## 5.4 Industry Standard Nondestructive Evaluations

## 6 Destructive Validation of Nozzle 63

## 7 Correlation of Ultrasonic and Destructive Results

Figure 5.17 Ultrasonic Data from Nozzle 63 as Obtained by WesDyne International. The image was acquired with a 5-MHz probe. The horizontal axis represents the nozzle circumference in units of degrees. The vertical axis represents the nozzle axis in units of millimeters.

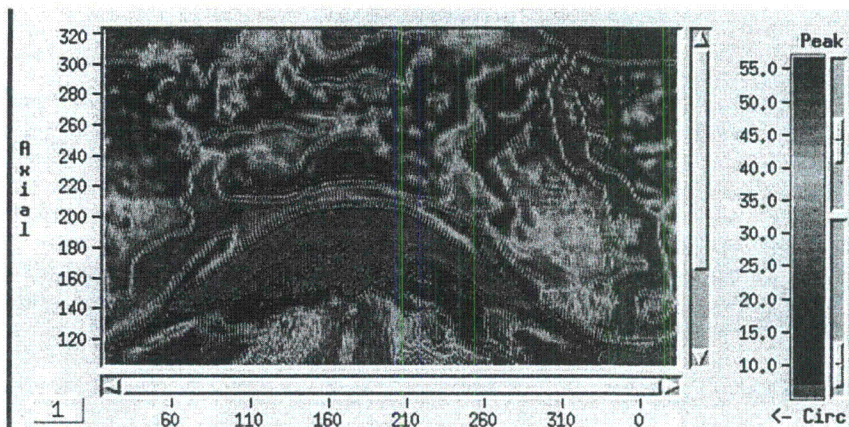
Comment [PG041]: Remove this.

**Figure 5.19** Eddy Current Data (WesDyne International) Showing Two Axial Flaws. The horizontal axis represents the nozzle circumference in degrees. The vertical axis represents the nozzle axis in millimeters.

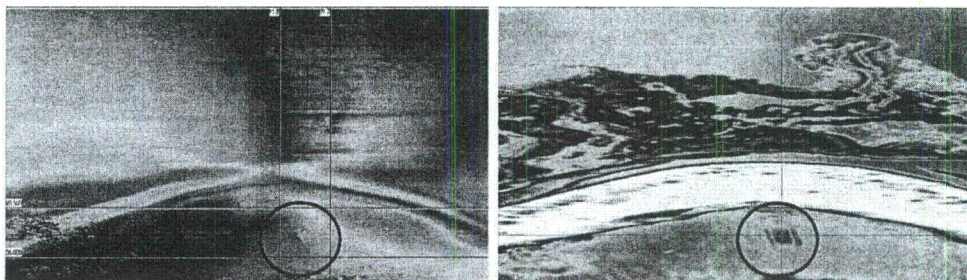
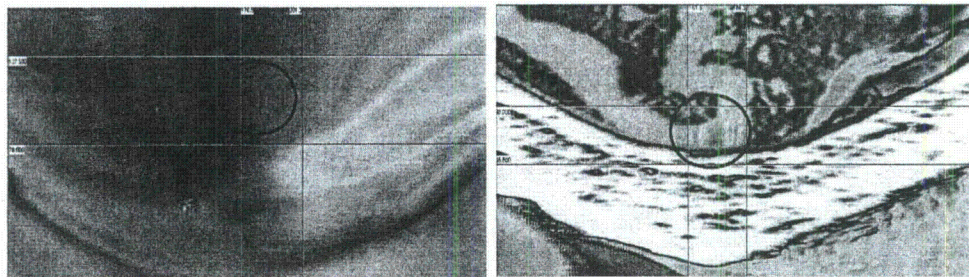
**Comment [PG042]:** What is the difference between the top and bottom image?

**Figure 6.2 Size Reduction Cutting Activity**

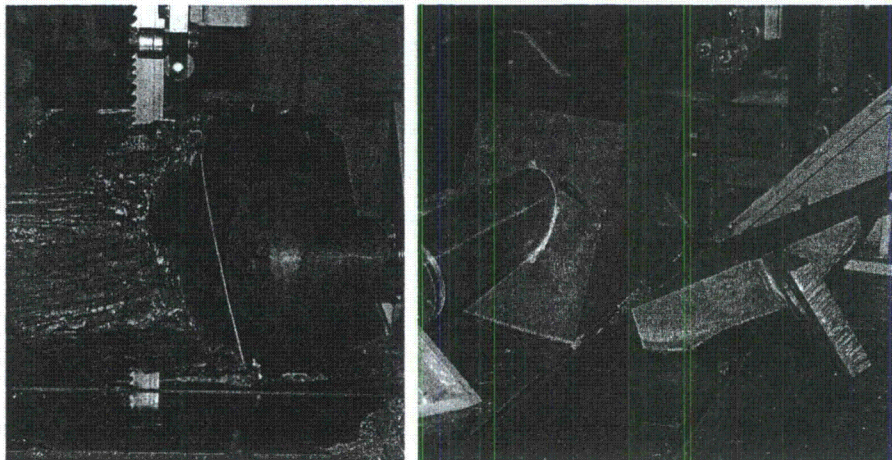
**Comment [PGO46]:** Can keep this figure.

**Figure 6.3 Start of the Dissection Cut**

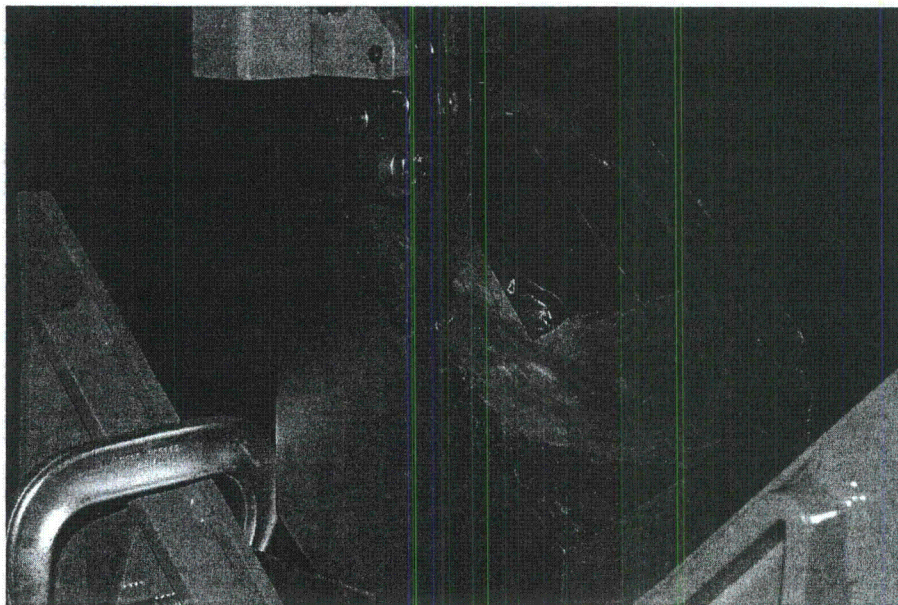
**Comment [PG047]:** Keep this figure.

**Figure 6.4 Abrasive Carbide Blade Progressing Through the Hard Spot**

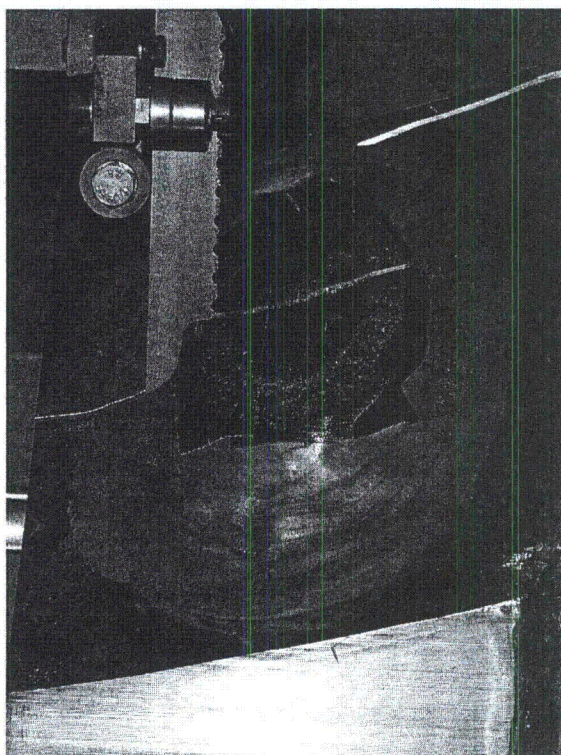
**Comment [PG049]:** Remove this figure.

**Figure 6.5 Nozzle 63 Assembly Cut in Half by Dissection Cut**

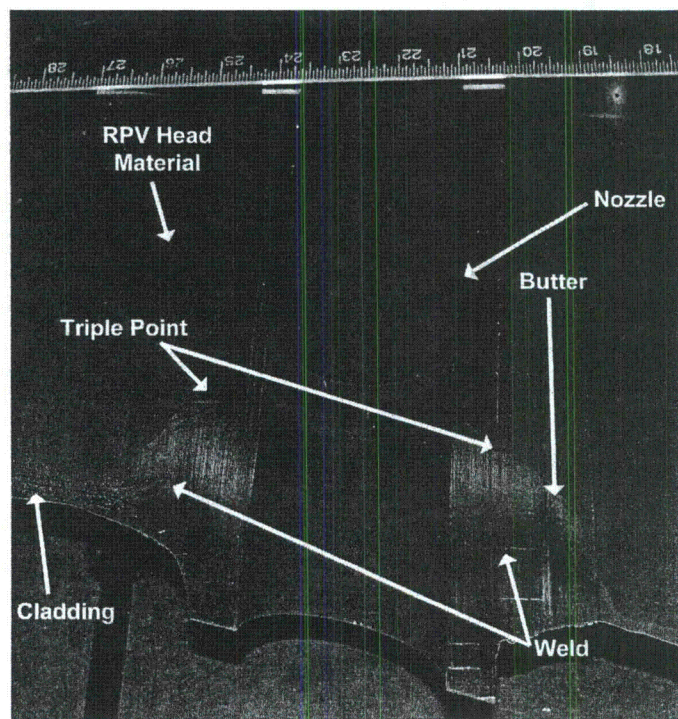
**Comment [PG050]:** Keep this figure. Remove all labels except RPV head and weld. Draw a line on this figure to show where the weld removal cut was made.

Figure 6.6 J-groove Weld Removal Cut Line Placement

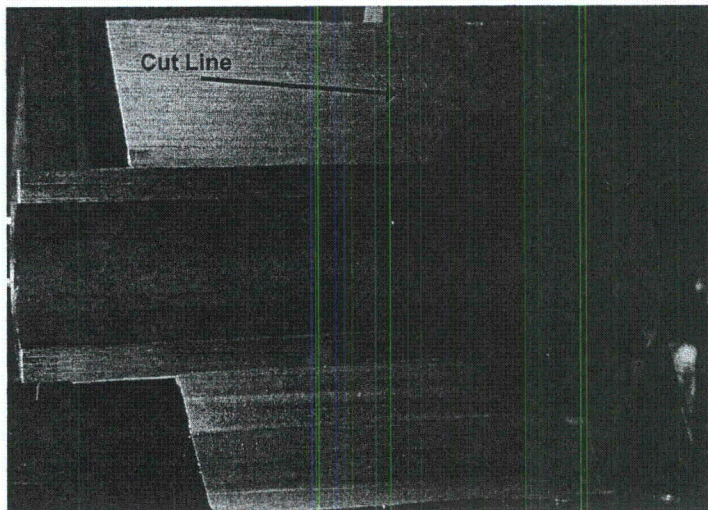
Comment [PG051]: Remove this figure.

**Figure 6.8 Abrasive Blade Cutting Through the Nozzle with a HEPA Vacuum Nozzle**

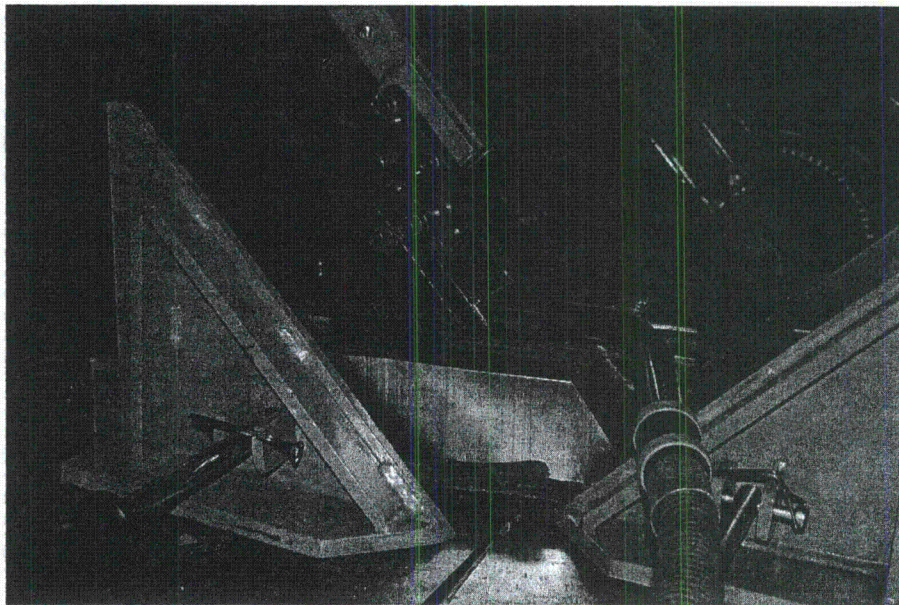
**Comment [PG053]:** Remove this figure.

Figure 7.3 Ultrasonic Data Overlaid on RPV Head Photograph with Opacity Varying from 10 to 60%, Top to Bottom

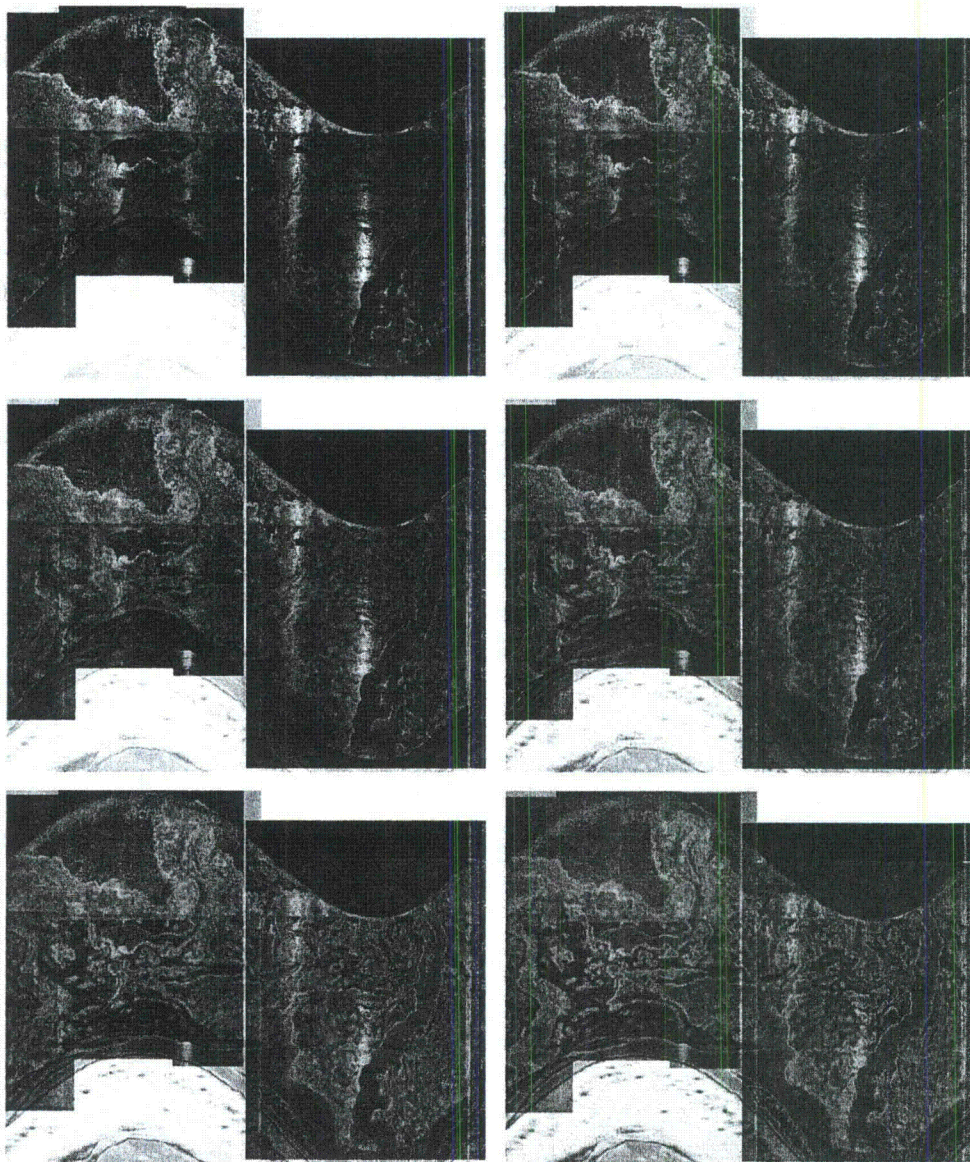
**Comment [PG055]:** See comment on Figure 7.3. This picture should be on the same page as the UT data so that they can be easily compared.

**Comment [PG056]:** You don't need all the overlaid images. We do need on the same page Figure 7.2 and the UT data on the same size scale next to each other, or one on top of the other.

**Figure 9.1** Photograph of the RPV Head Material with Boric Acid Measurement Points

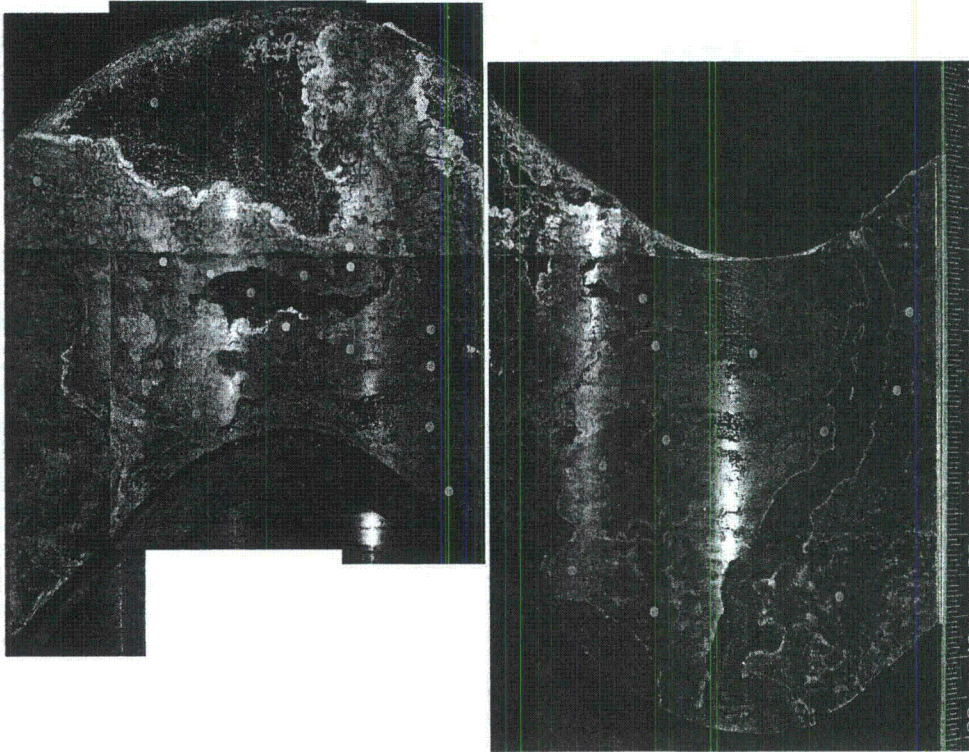
**Comment [PG060]:** State what the dots are and the significance of the color scheme. Mark the span of the interference fit.

Figure 9.3 Boric Acid Thickness Values in Microns

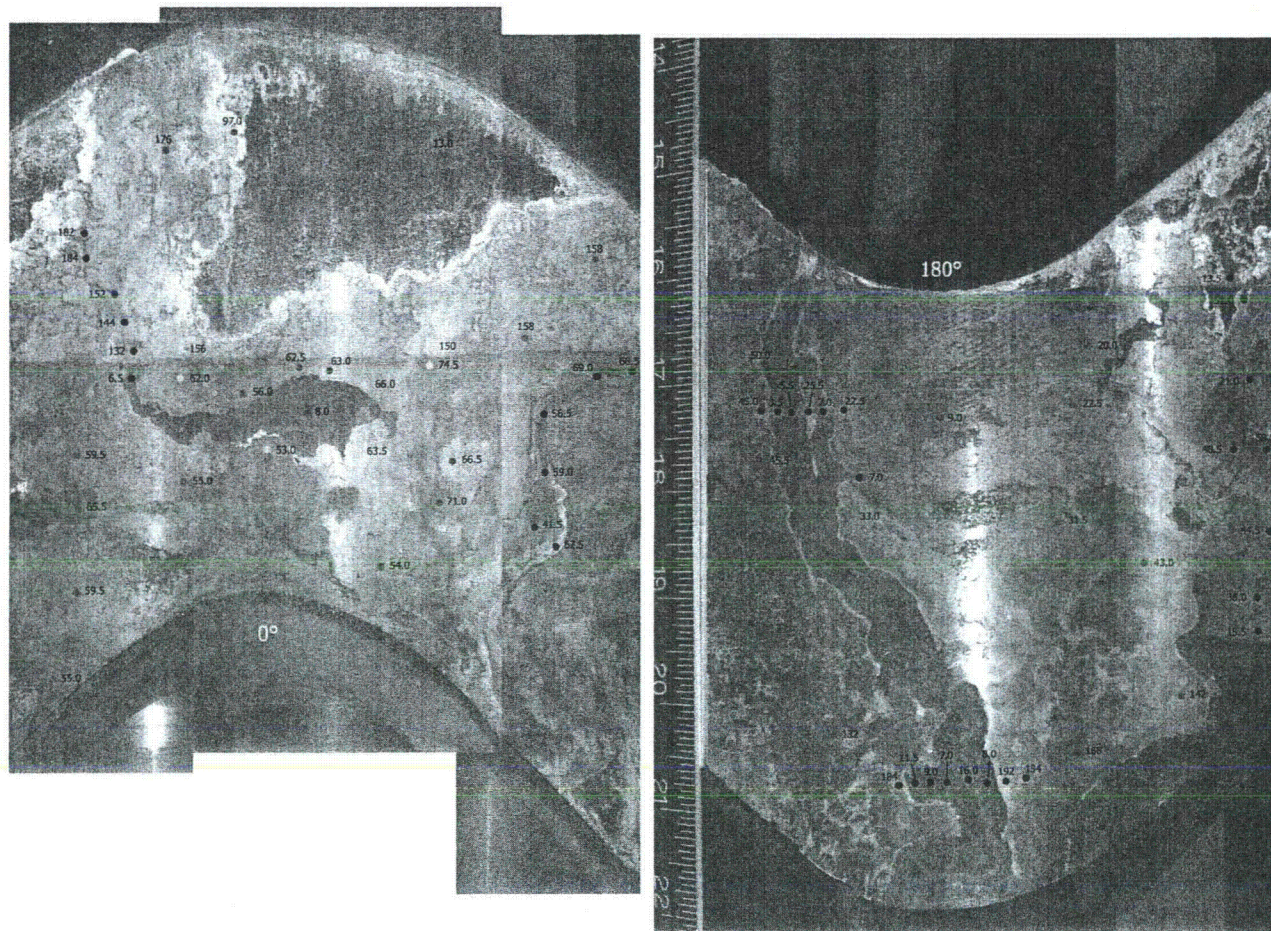
**Comment [PG061]:** Remove this figure

**Figure 9.4** Ultrasonic Amplitude as a Function of Boric Acid Thickness from Points in the Interference Fit Region

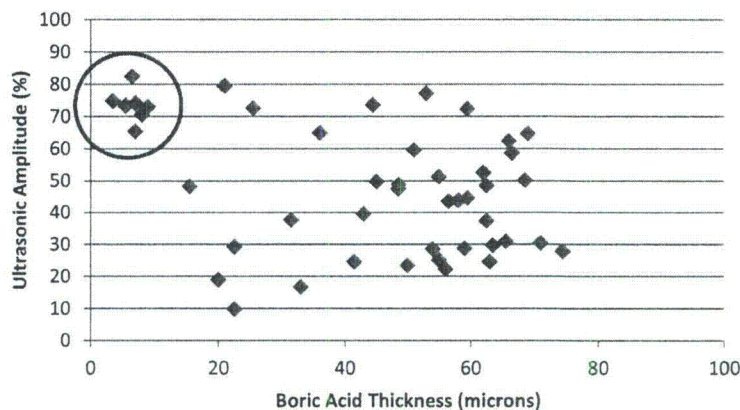
**Comment [PG063]:** The numbers are small and hard to read. Is there a way to make larger?

Comment [PG064]: Remove figure.

**Figure 9.5** Ultrasonic Amplitude as a Function of Boric Acid Thickness from Points Above and Below the Interference Fit Region

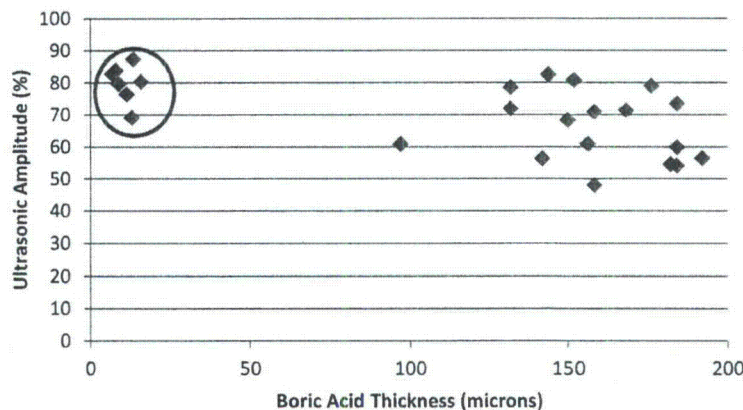
Comment [PG065]: Remove figure.

**Figure 9.6 Overlay of Ultrasonic Image on the 70 Measurements Points**

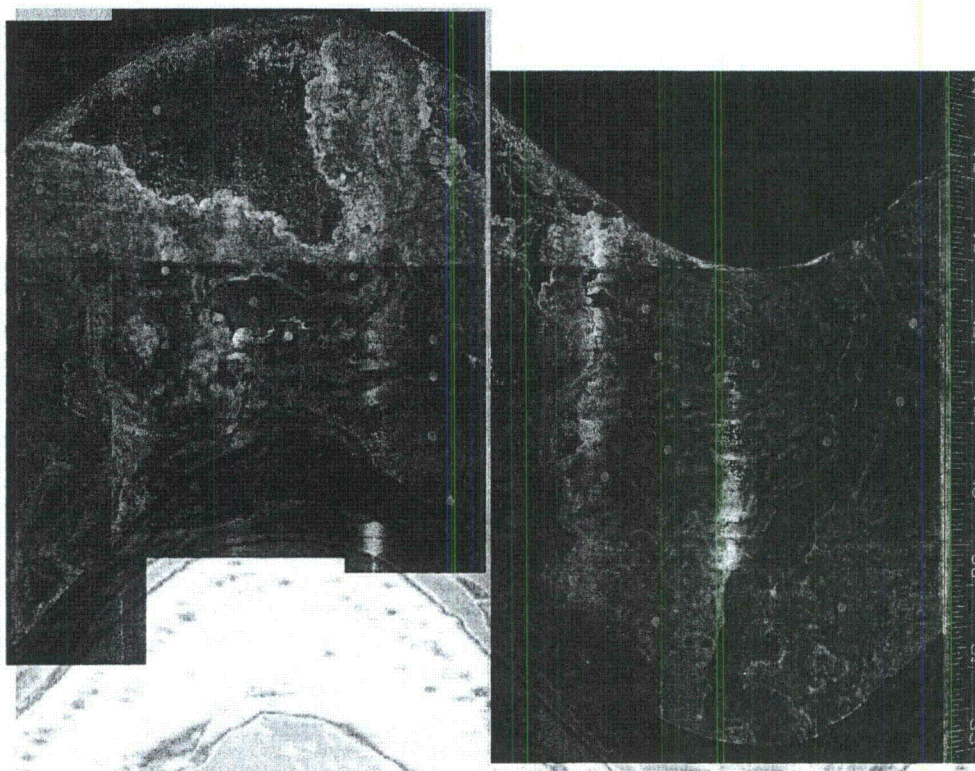
Comment [PG066]: Remove figure.

Figure 9.7 Eight Areas Selected for Boric Acid Thickness Measurements on Cross-Sectional Slices of Microset Replica

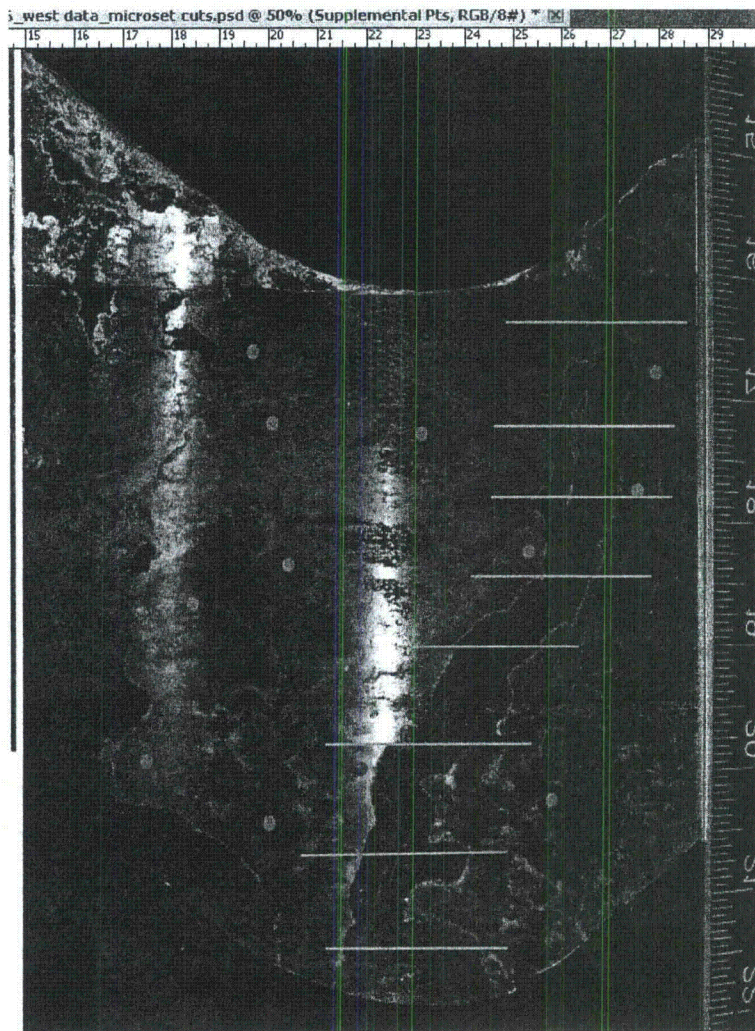
Comment [PG073]: Remove dots from figure except those for the horizontal line measurements.
